Urgent Field Safety Notice

Claria MRI™ CRT-D SureScan™ and Amplia MRI™ CRT-D SureScan™

12 December 2016

Medtronic reference: FA747

Figure 1

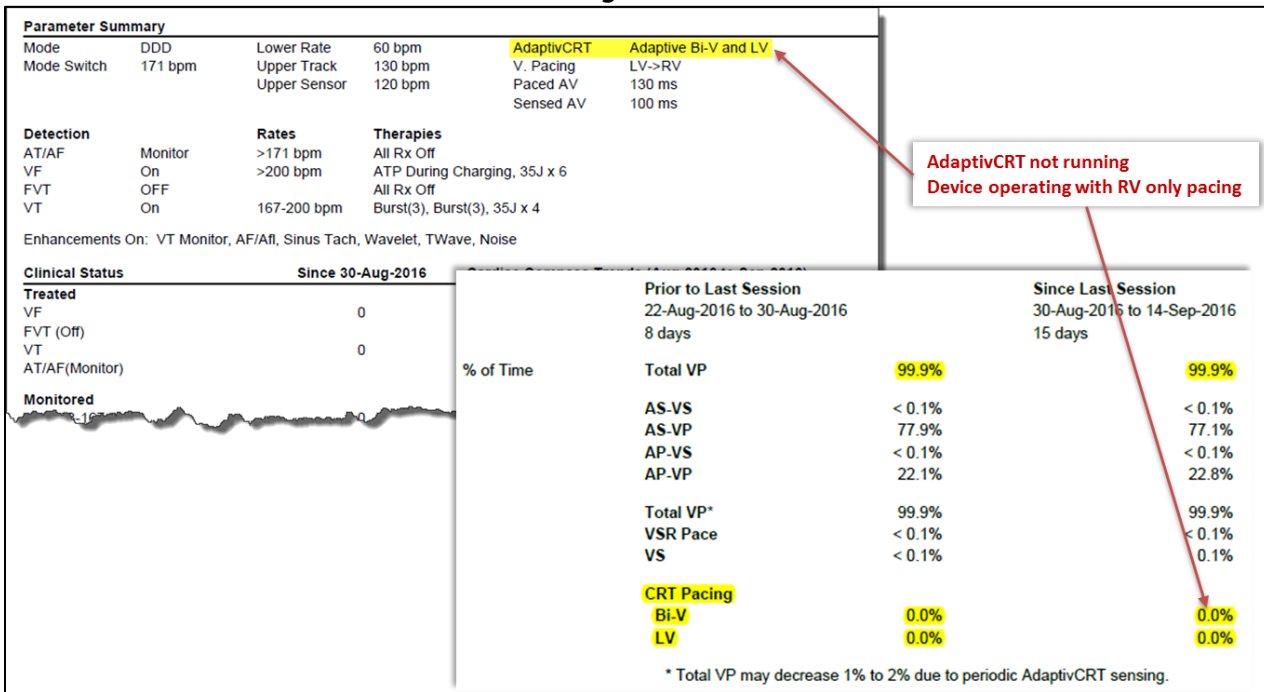
When a patient with AdaptivCRT enabled (shipped setting) is subsequently programmed to MVP mode and then re-programmed back to DDD or DDDR, AdaptivCRT is not re-enabled. When this programming sequence occurs, LV pacing is not delivered, despite parameters indicating AdaptivCRT is enabled (Appendix B, Figure 1). This will result in RV only pacing which may be undesirable for the patient. LV pacing will remain disabled until a specific programming sequence is manually completed; refer to the Patient Management section of this letter (Appendix B) for details.

- If the CRT setting is currently programmed to *Adaptive Bi-V and LV* or *Adaptive Bi-V* (Figure 1), review rate histogram CRT Pacing percentages (CRT Pacing: Bi-V and LV).
- If Bi-V and LV pacing percentages *Since Last Session* are both near 0%, then the device has encountered the programming sequence and has lost LV pacing; proceed to step 2.

- Select the CRT parameter window, select *Nonadaptive CRT*, and select *PROGRAM*.
- Select the CRT parameter window, select the desired AdaptivCRT setting (*Adaptive Bi-V and LV* or *Adaptive Bi-V*), and select *PROGRAM*.
